**UNITED STATES ENVIRONMENTAL PROTECTION AGENCY
REGION 10**

Re: EPA Region 10 Review of the Upper Lochsa Land Exchange Supplemental Draft Environmental Impact Statement. EPA Project Number: 08-068-AFS.

**EPA Region 10 Comments on the
Supplemental Draft EIS for the
Upper Lochsa Land Exchange**

Fig 1: IFPA buffers on Lightning Cr.

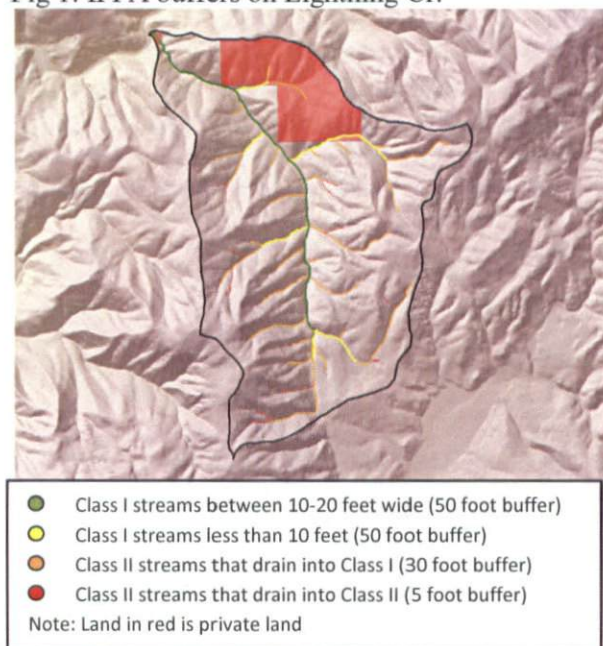
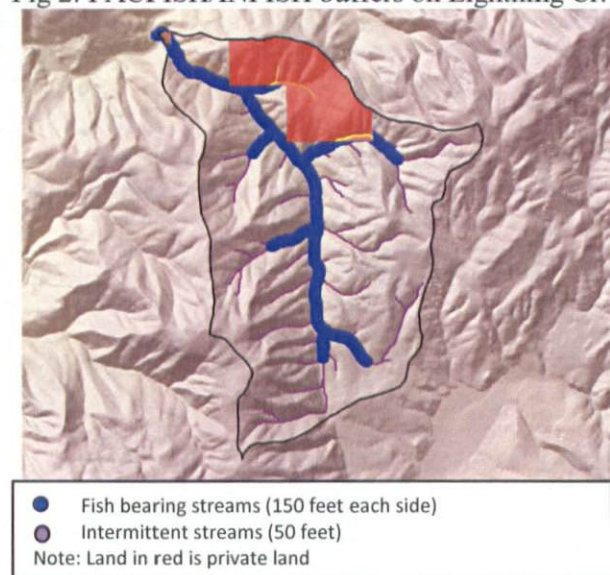
Figures 1 and 2 depict how these strategies would be applied within the Lightning Creek drainage.

We applied a shade model to the mainstem of Lightning Creek. In this modeling exercise we assumed the buffers outlined in Figures 1 and 2 above. In order to simplify this modeling effort we did not assume any management (i.e. thinning) within those buffers. Area outside the buffer was assumed to be clearcut. Our results indicate that for the mainstem of Lightning Creek, management under IFPA would result in a reduction in shade relative to management under PACFISH/INFISH. Figure 3 depicts the

- We recommend that the FSEIS include an analysis of water quality impacts that crosswalks shade targets established in the SF CWR TMDL with the management prescriptions that would be applied in riparian zones under the IFPA and PACFISH/INFISH.
- Where shade targets cannot be achieved, we recommend that parcels be removed from consideration for exchange, or be subject to a term of exchange that would require greater riparian protection to meet SF CWR TMDL targets.

Figure 3: Percent Reduction in Effective Shade under PACFISH/INFISH and IFPA on Lightning Cr.

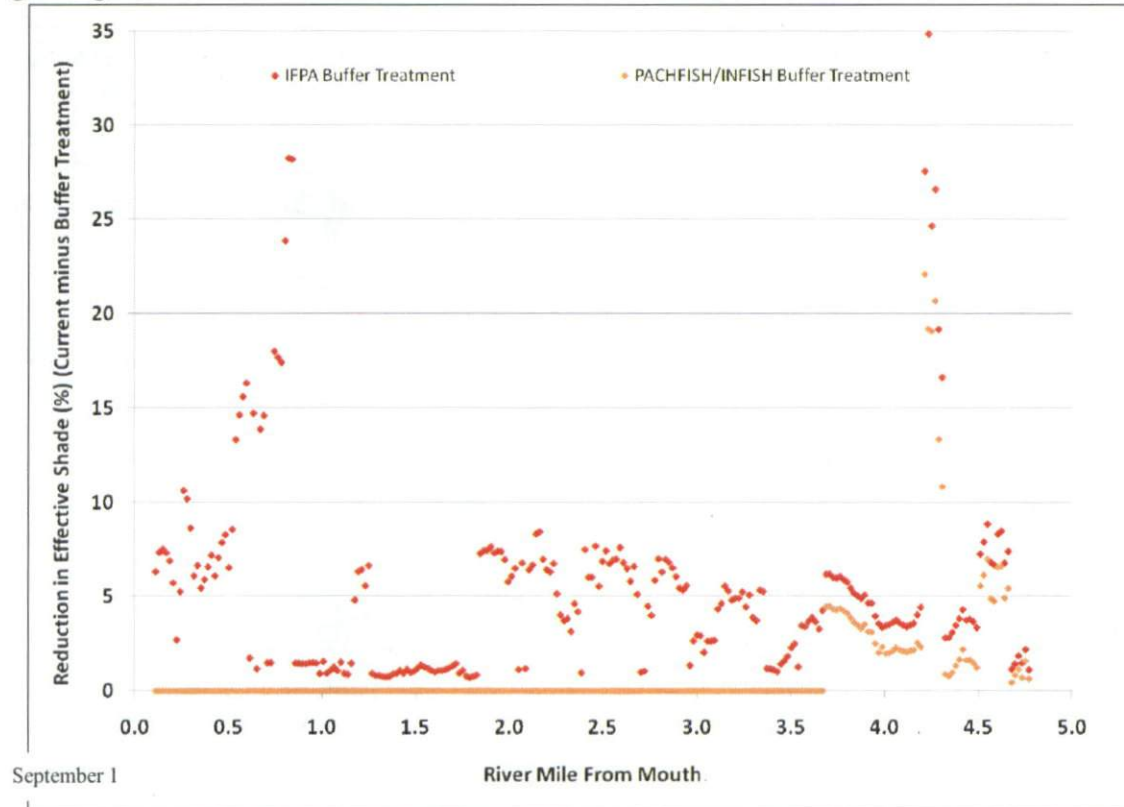
relative percent reduction in effective shade on Lightning Creek under PACFISH/INFISH and IFPA on September 1.
